**SECTION 009113
ADDENDUM NUMBER 3**

1.02 PROJECT: GRAHAM CREEK AG BUILDING

Re: Graham Creek Ag Building - RFI responses to questions received in writing, Addendum 03

1 BUILDING FLOOR PLAN & GUTTER DIAGRAM
 1/4" = 1'-0"

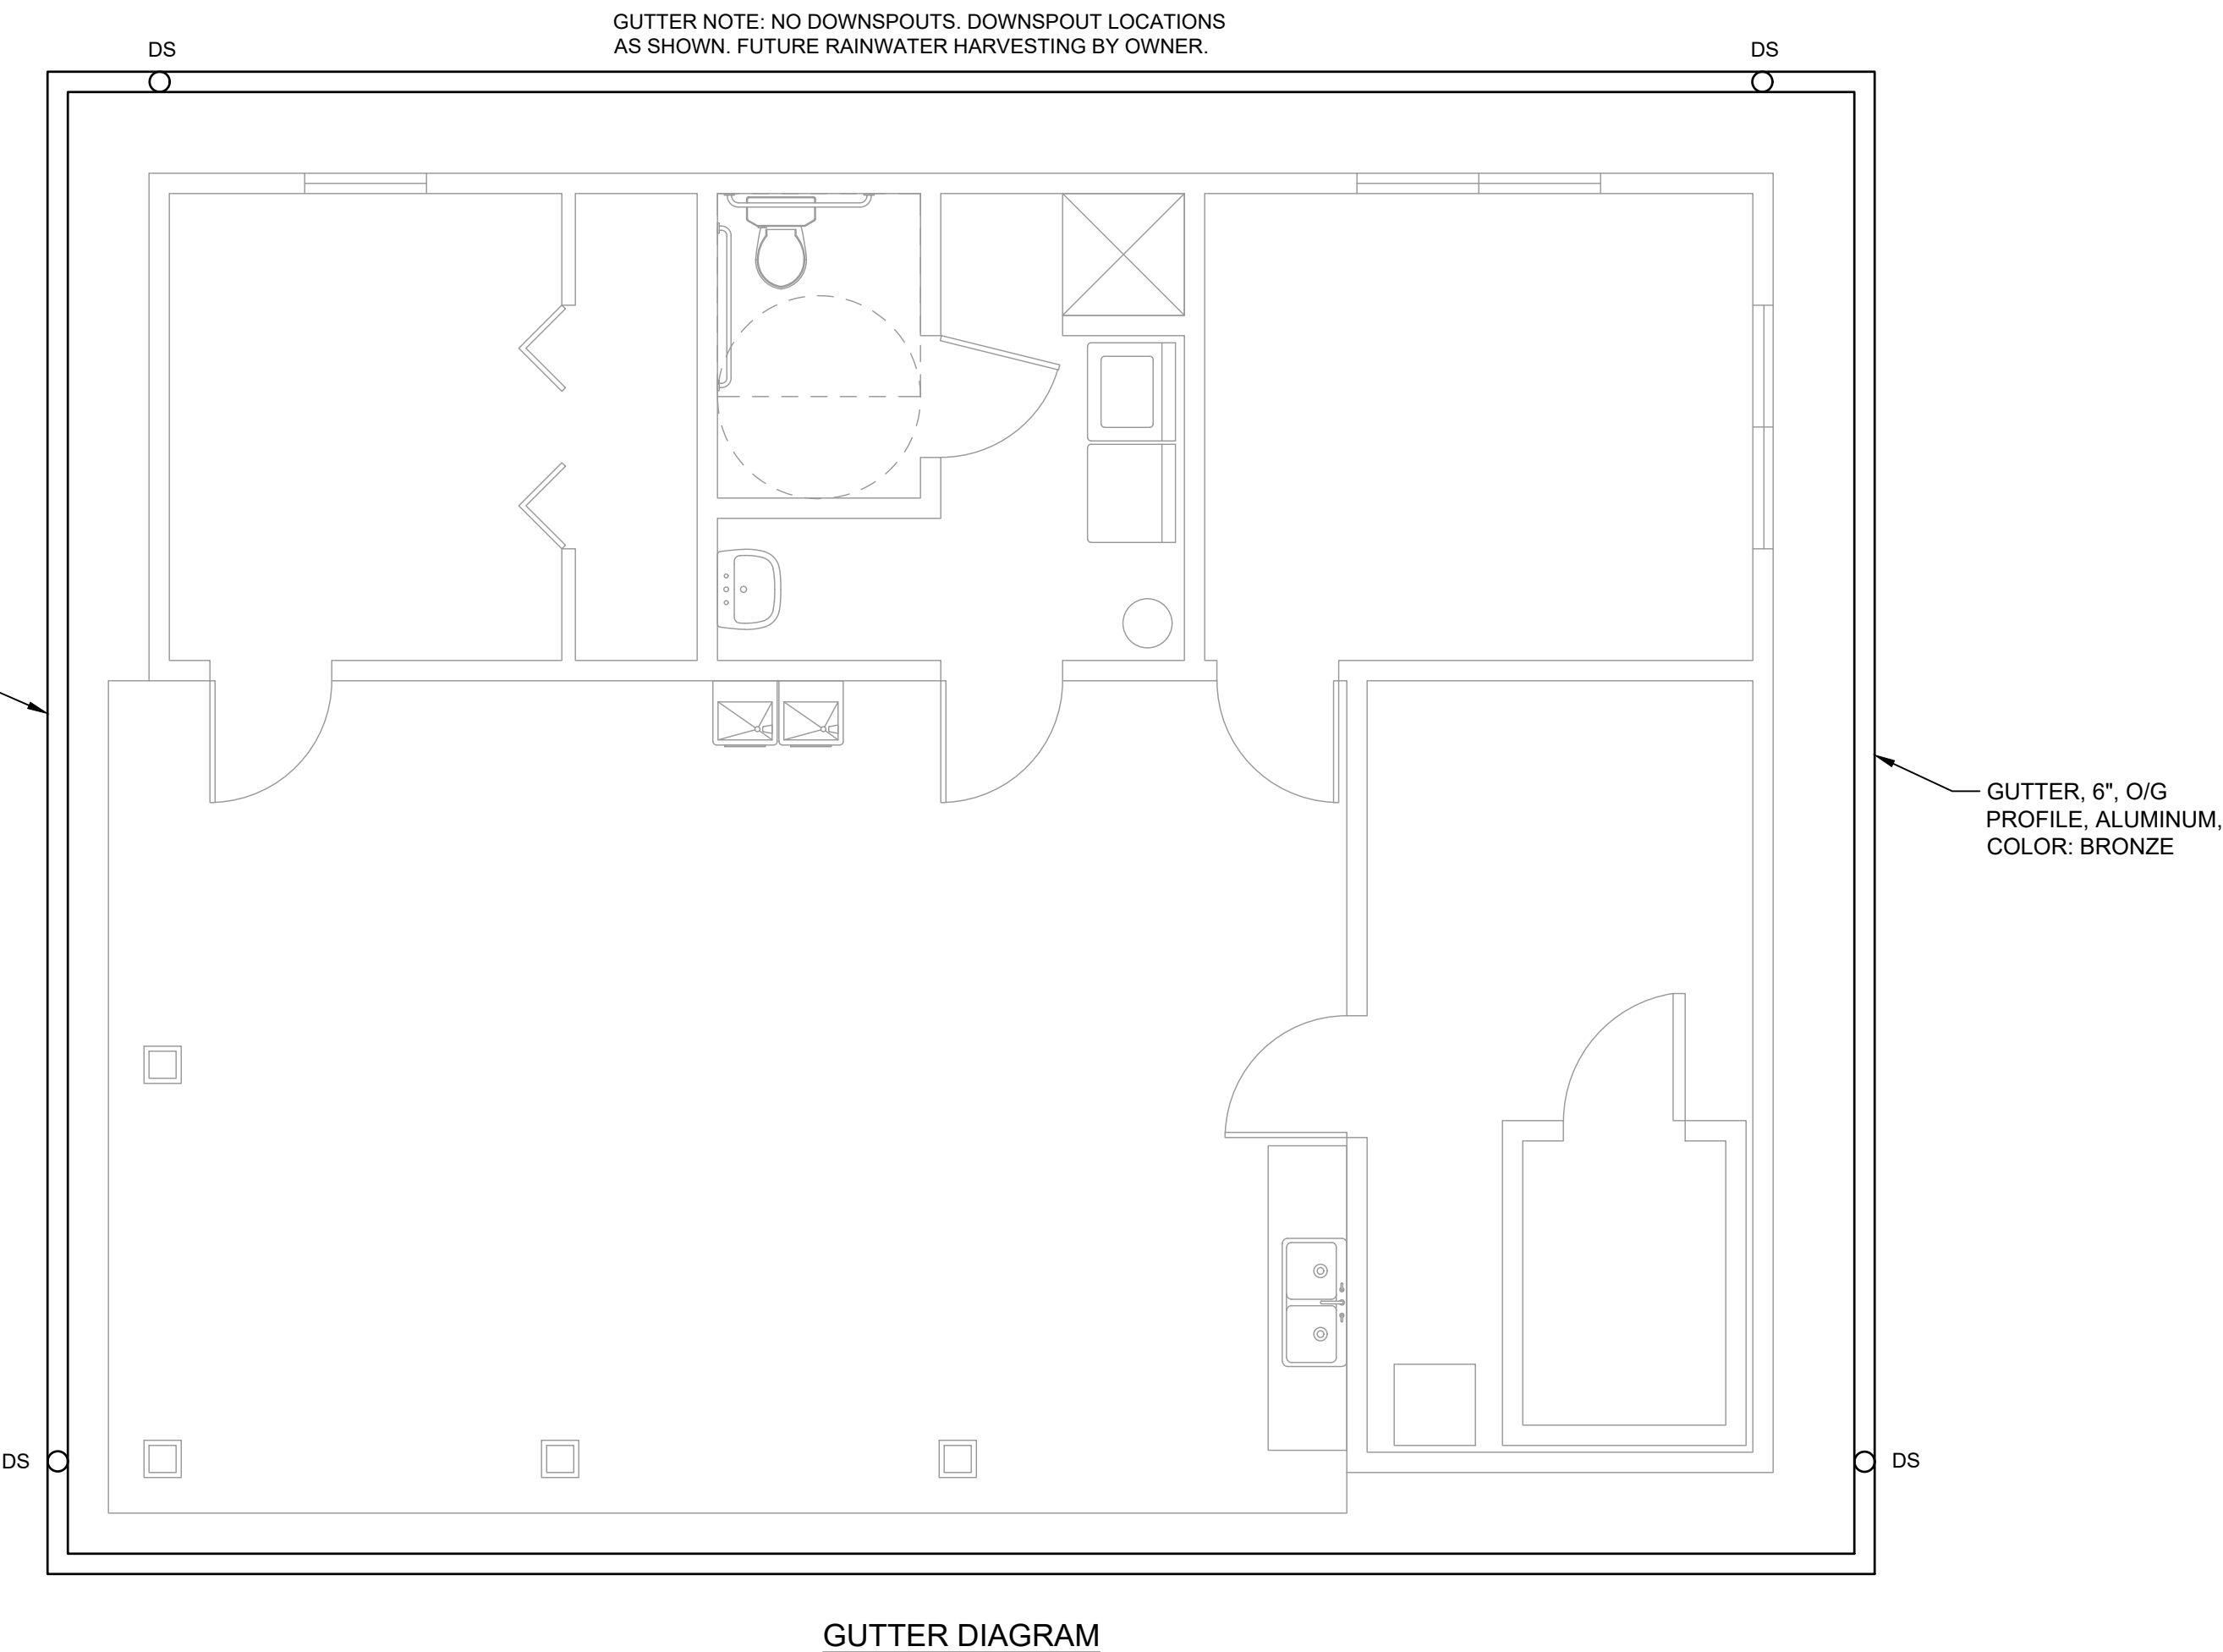
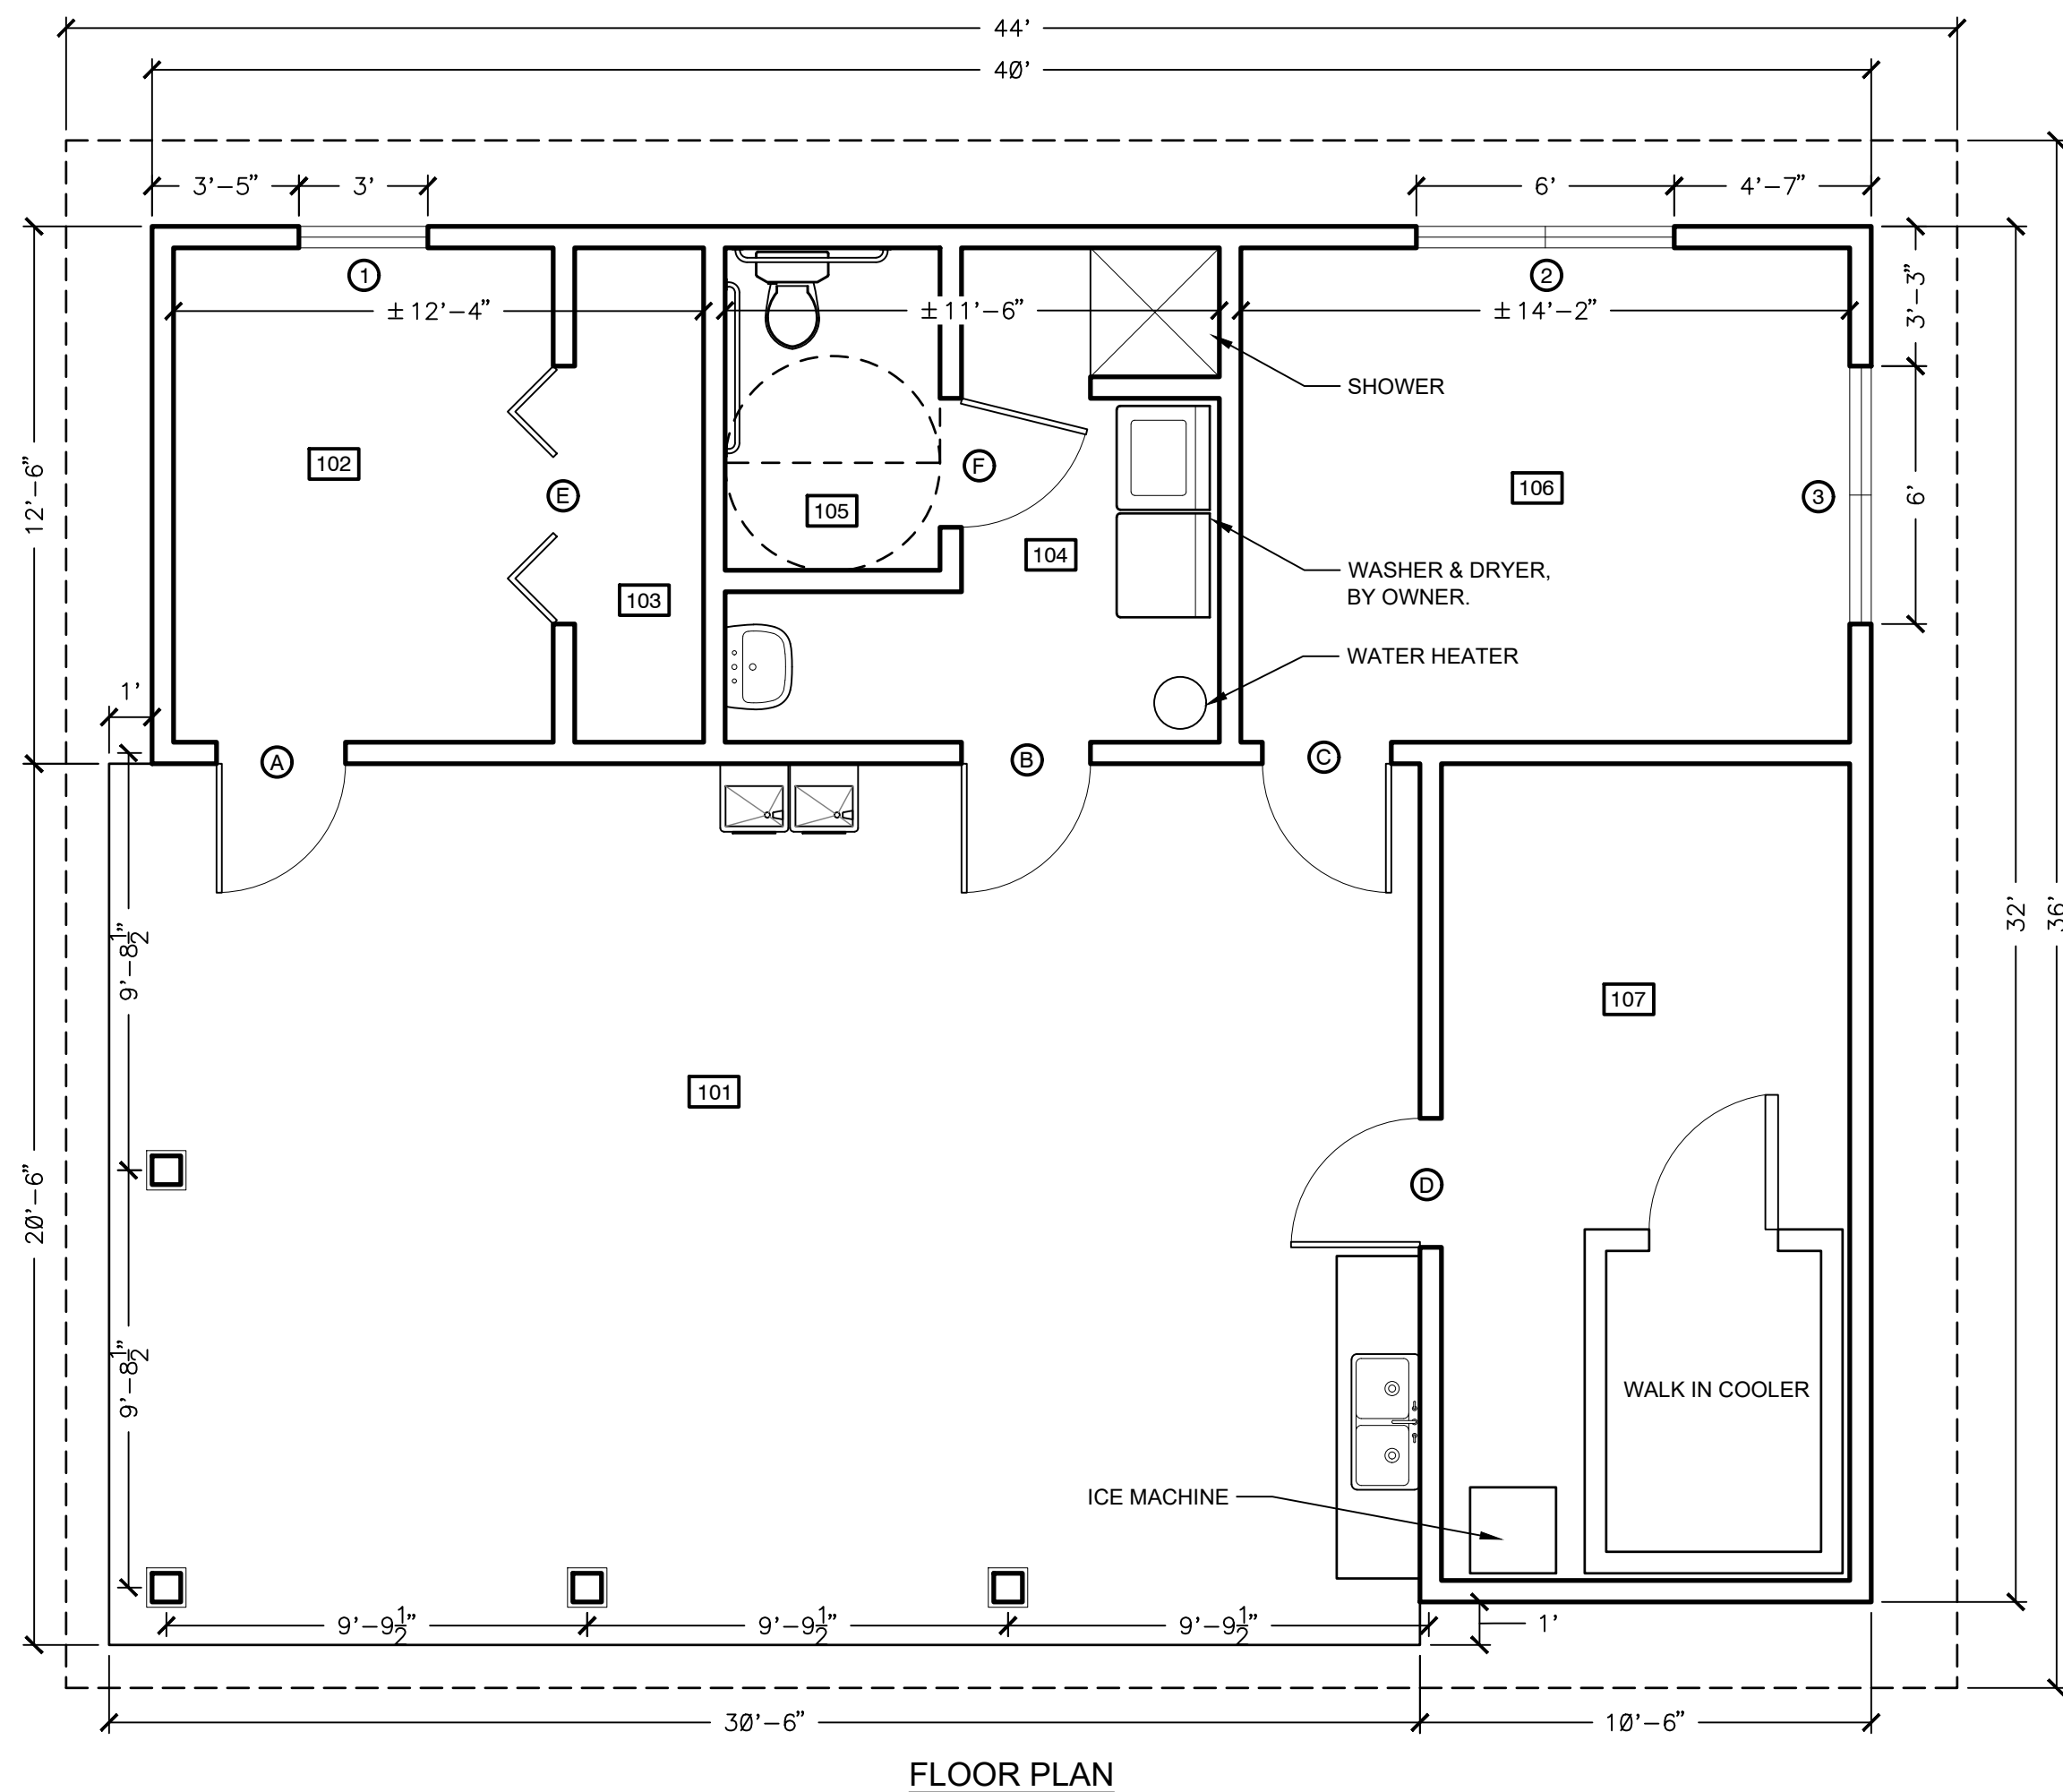
- 9) Is the GC responsible for the cabinets? If so, what are the materials, dimensions, etc?
 - a) No, the GC is not responsible for cabinetry. Cabinetry and furniture has been removed from the floor plan to eliminate confusion.

- 13) Will a toilet partition door be required for the toilet?
 - a) No. The utility room layout was adjusted to include a toilet room that is ADA accessible.

2 ACCESSIBLE TOILET ROOM
1/2" = 1'-0"
010349-01

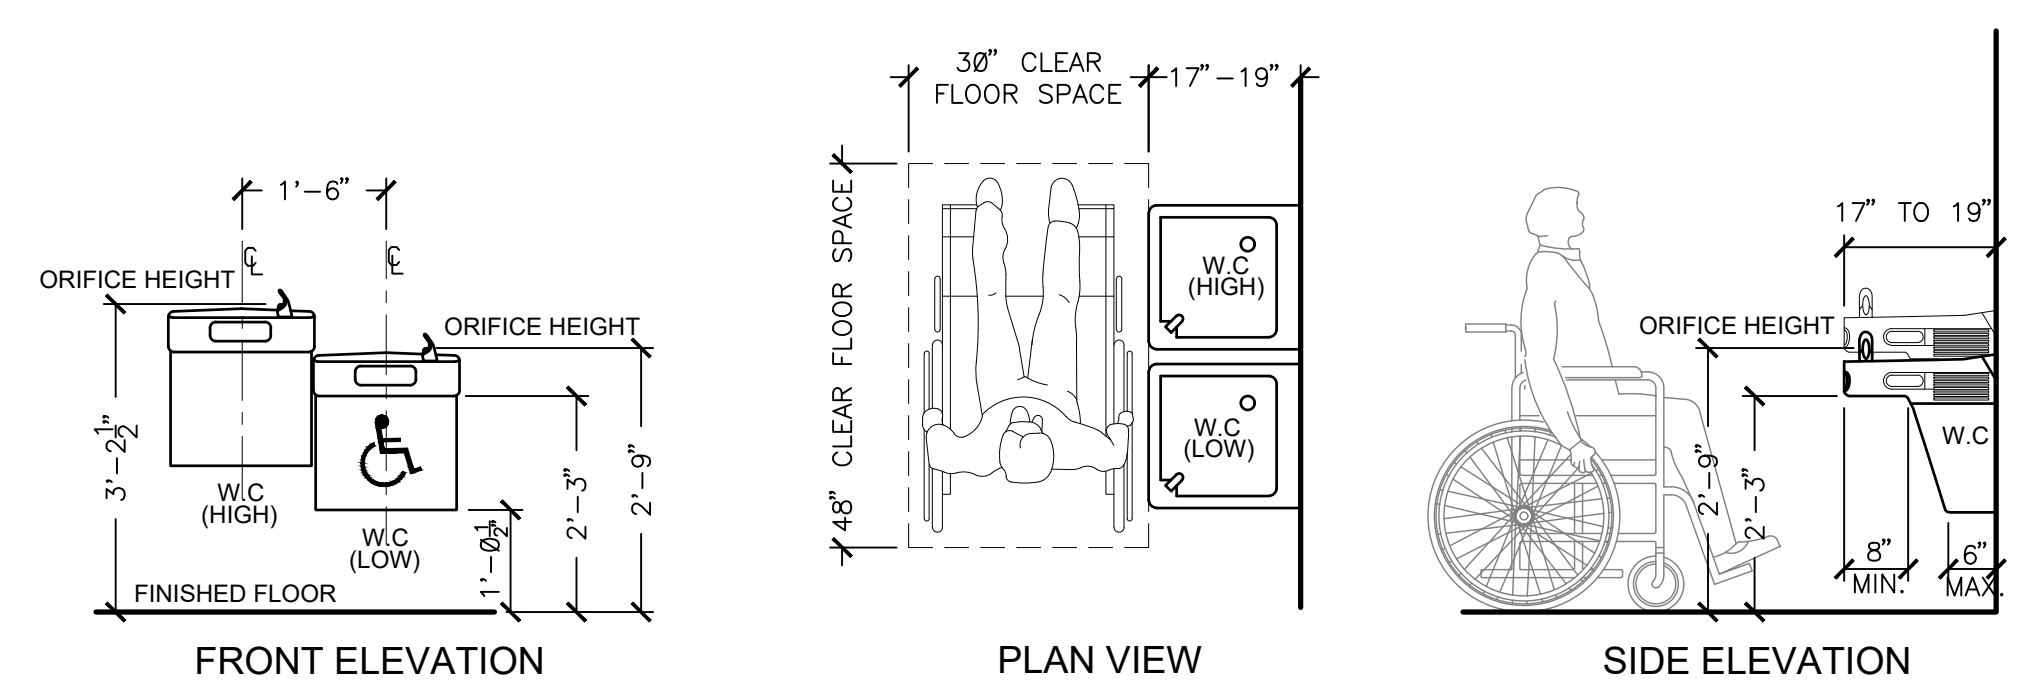
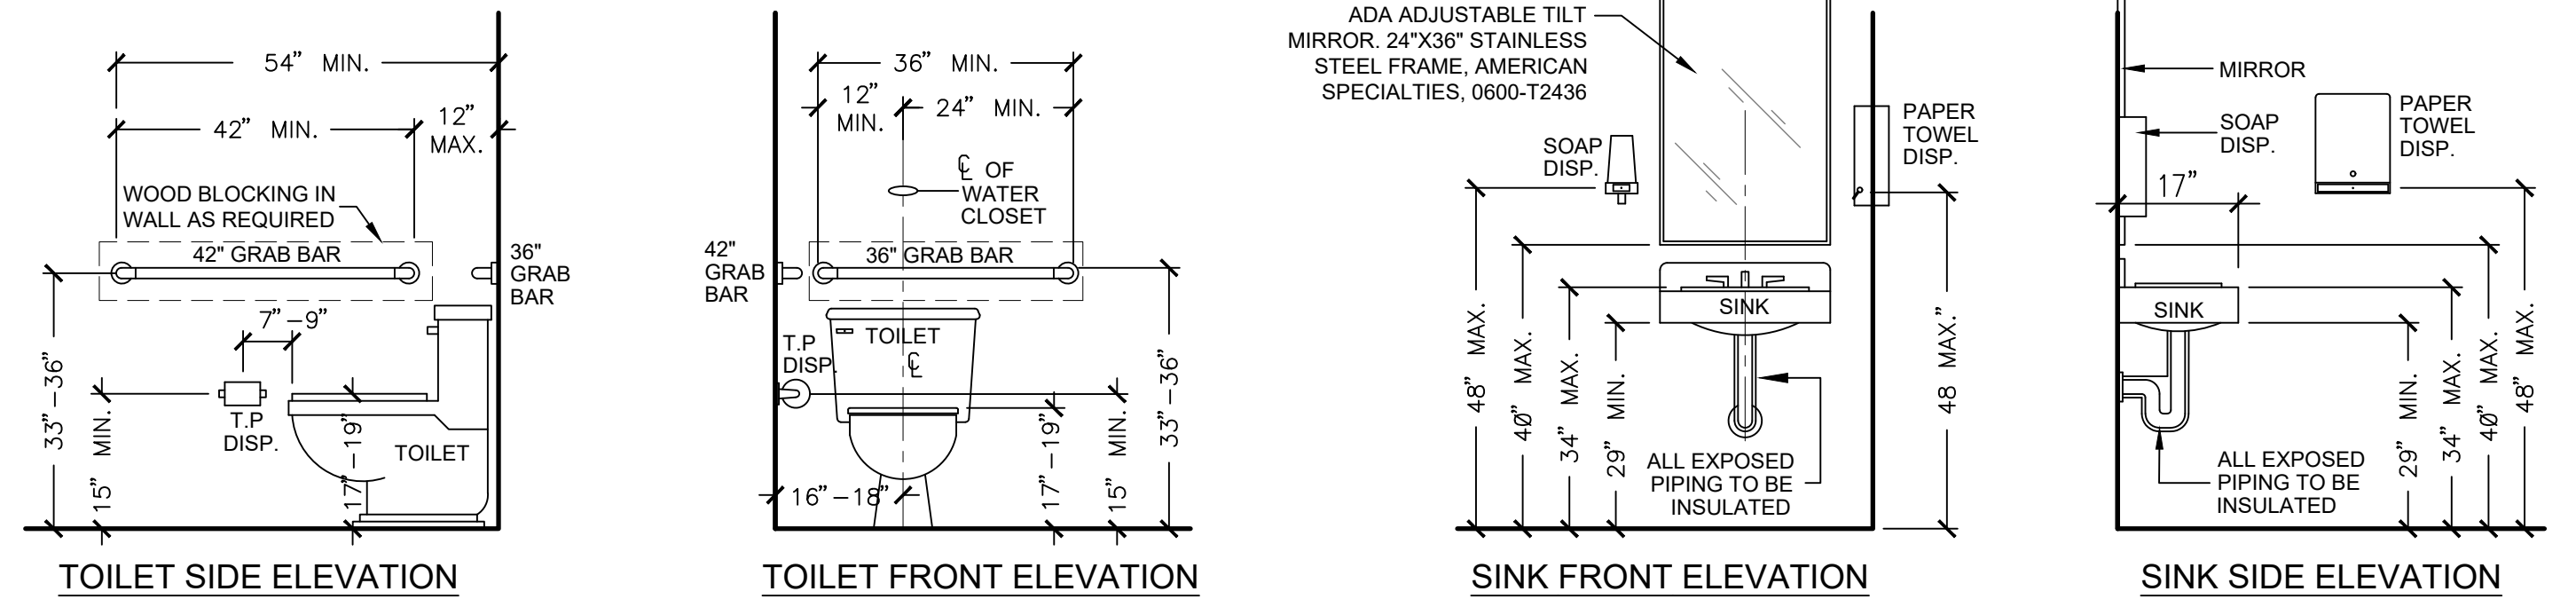
- 15) Are bathroom accessories required? If so, what are the specifications and counts?
 - a) Yes. Sheet AR504 includes a bathroom accessory schedule that lists the accessories and who is responsible for installation.
